SIMTA Intermodal Terminal Project – Stage 1

Peer Review of the Environmental Impact Statement

Project Number: 8201511201-01/Report 001 Ver 2

Prepared for
Liverpool City Council

Figure 4-6 Excerpt from the Georges River Casula Parklands Draft Master Plan

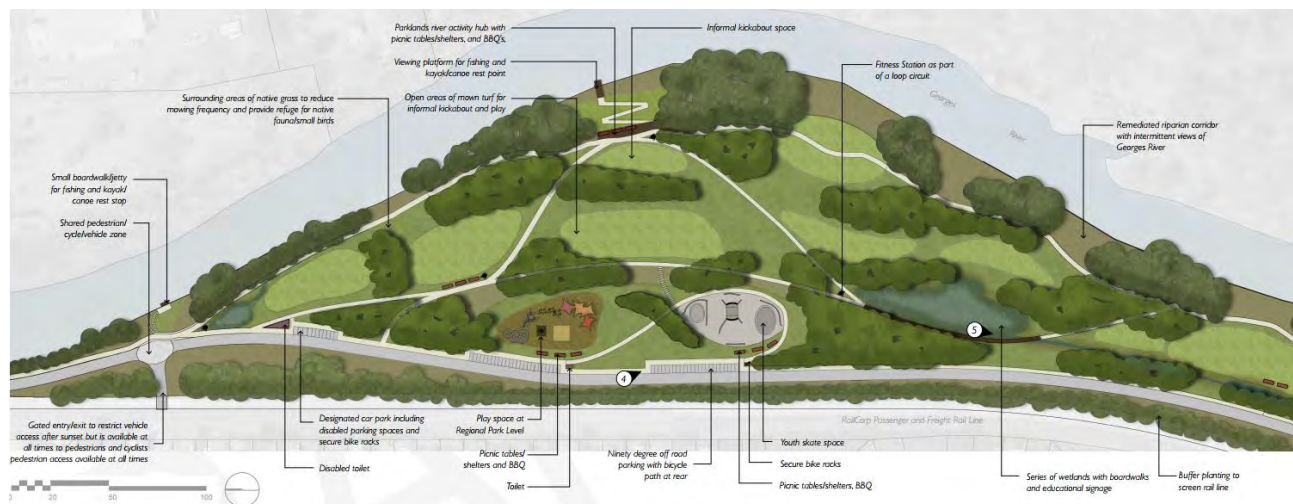
The Georges River is used by a number of recreational users throughout the year. This includes informal kayaking, canoeing and boating, along with a registered barefoot water-skiing club. The water-skiing club is located to the north of the M5 motorway, with its licence not extending to the section of the river located where the Rail Link occurs.

Despite this, the informal use of this area of the river is expected to increase into the future years. This is particularly likely due to the planned upgrade of the Georges River Casula Parklands surrounding the Casula Powerhouse Arts Centre. The Draft Master Plan for this area, particularly near the Powerhouse Arts Centre (refer to **Figure 4-6**), illustrates that a number of piers will be included to encourage recreational use of the river.
